RE: San Roque & La Serena
457 Coors Blvd NW
Permanent C.O. - Accepted
Engineer's Certification Date: 11/13/25
Engineer's Stamp Date: 11/10/2021
Hydrology File: J10D049
Case # HYDR-2025-00424

san roque & la serena
457 coors blvd. nw
albuquerque, new mexico 87121

Grading & Drainage Plan
c2.2

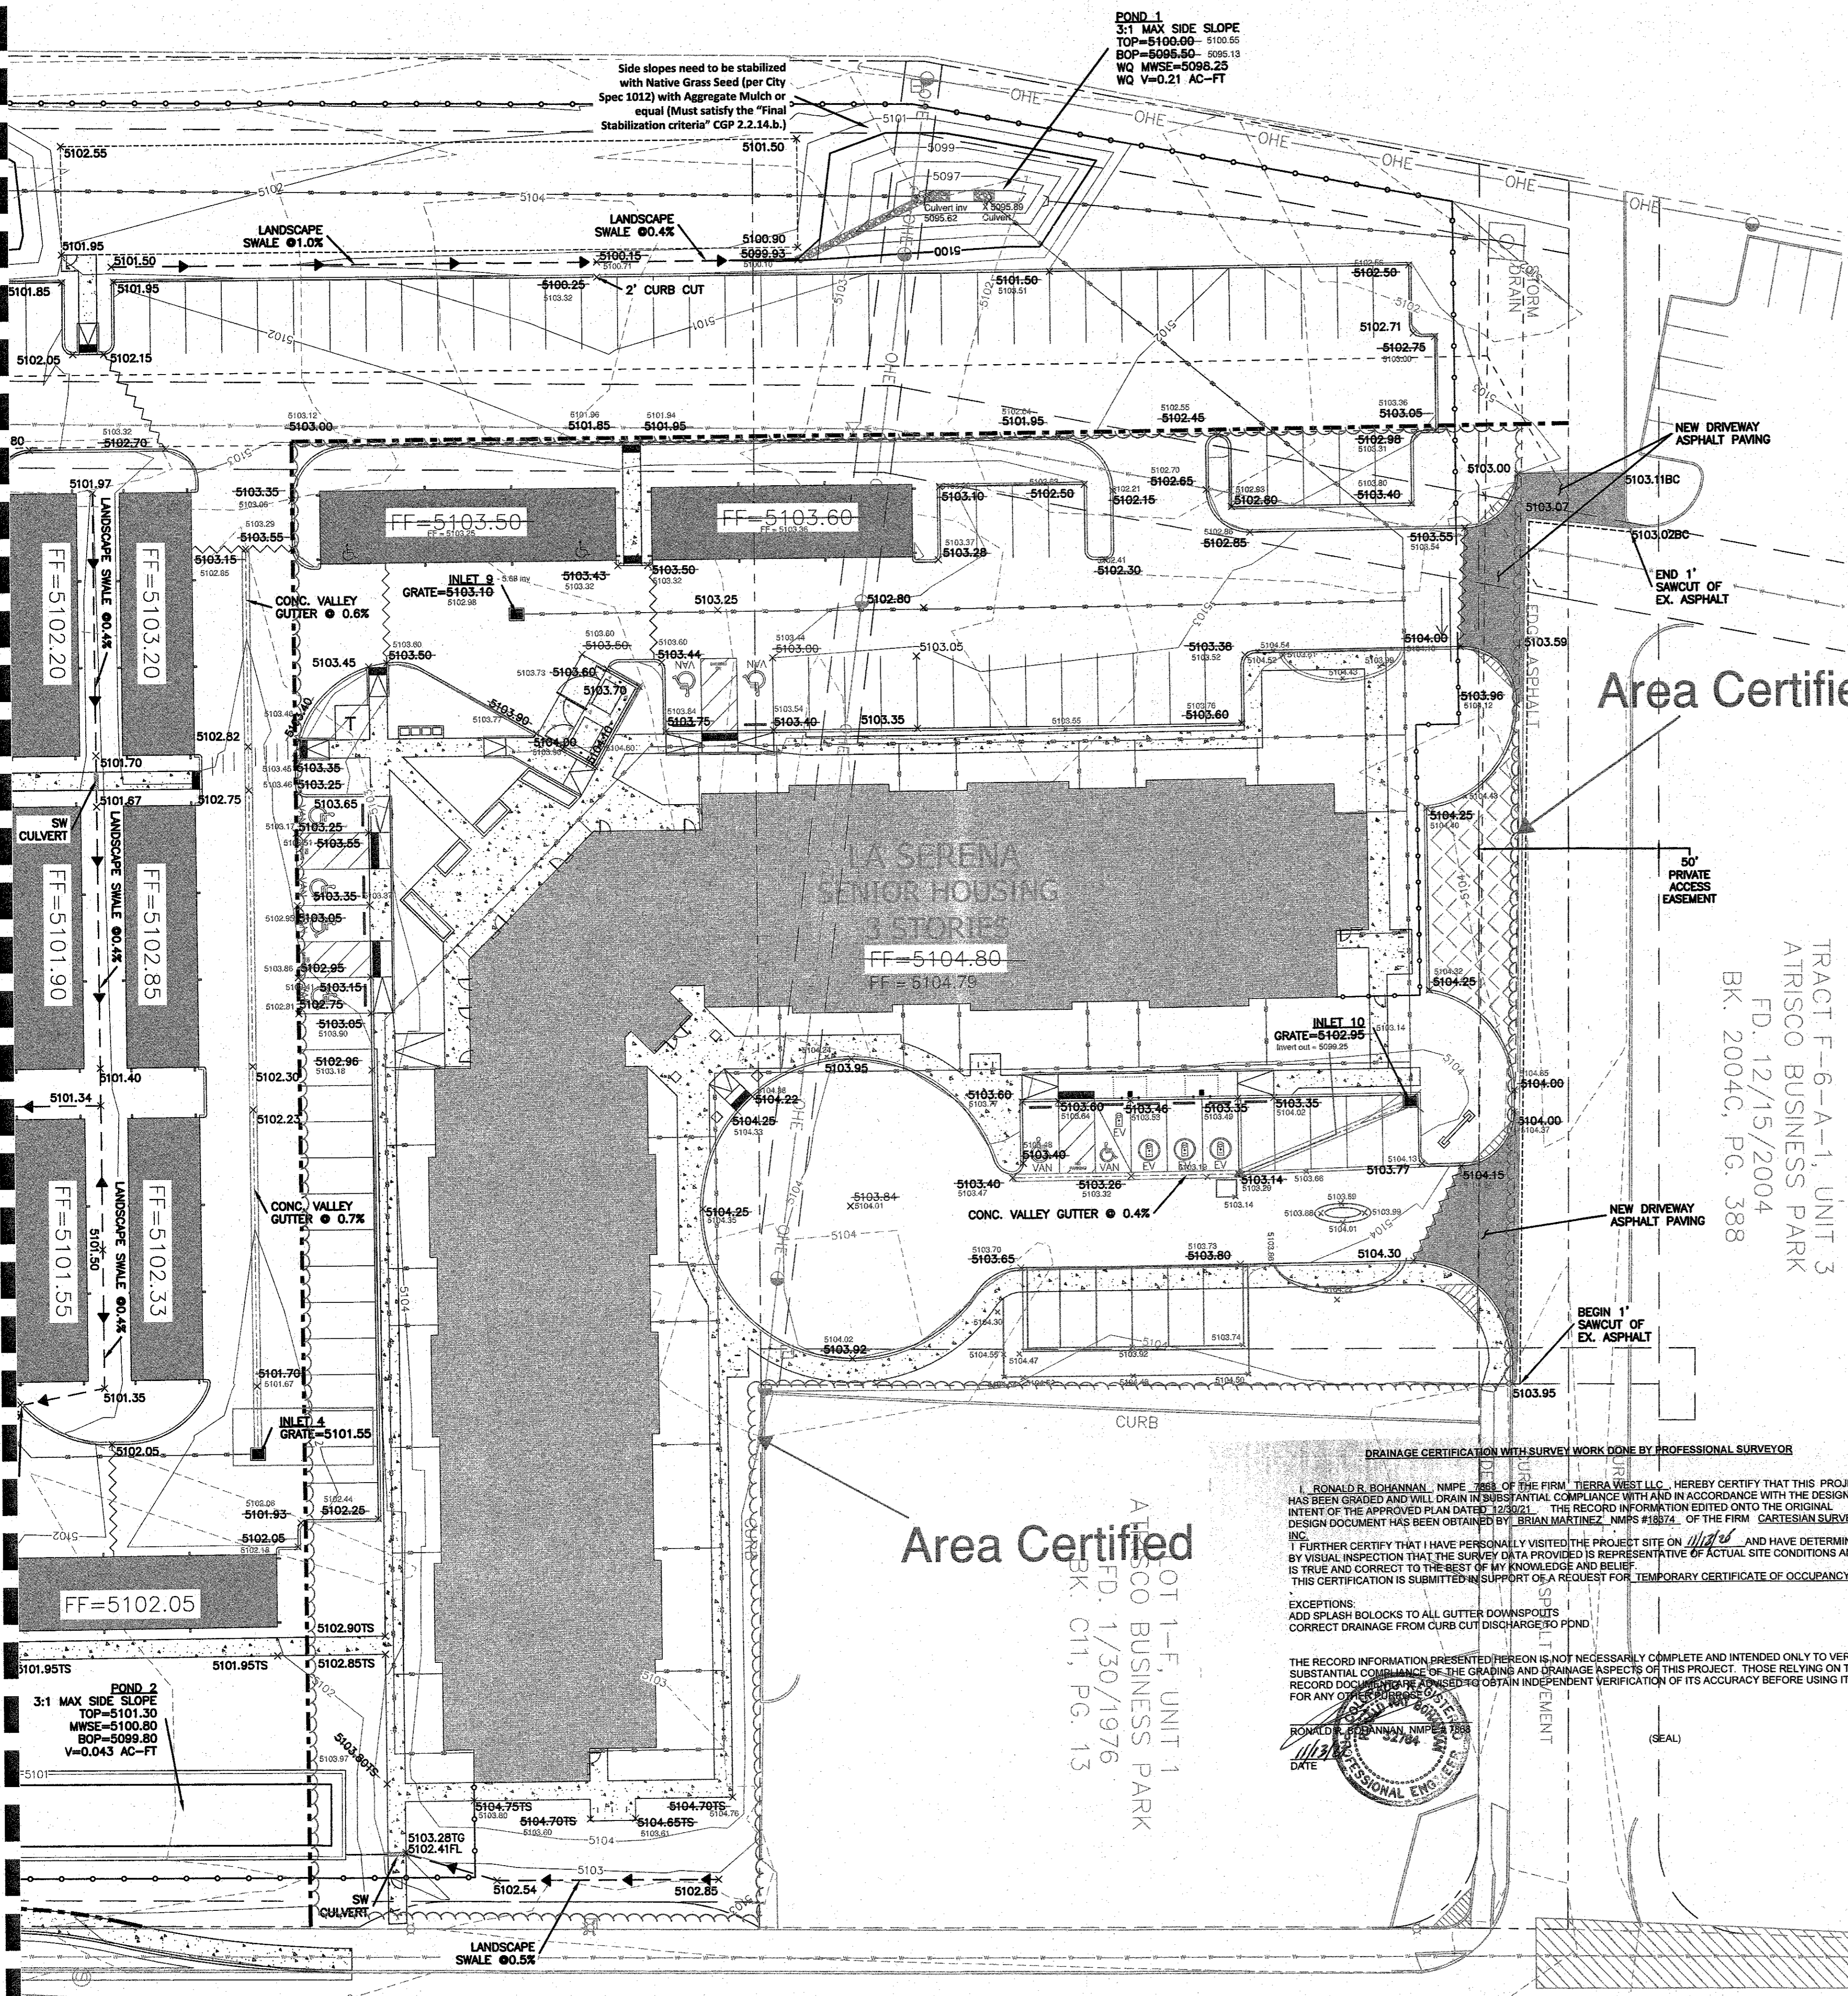
Side slopes need to be stabilized with Native Grass Seed (per City Spec 1012) with Aggregate Mulch or equal (Must satisfy the "Final Stabilization criteria" CGP 2.2.14.b.)

EXCEPTIONS:
ADD SPLASH BLOCKS TO ALL GUTTER DOWNSPOUTS
CORRECT DRAINAGE FROM CURB CUT DISCHARGE TO POND
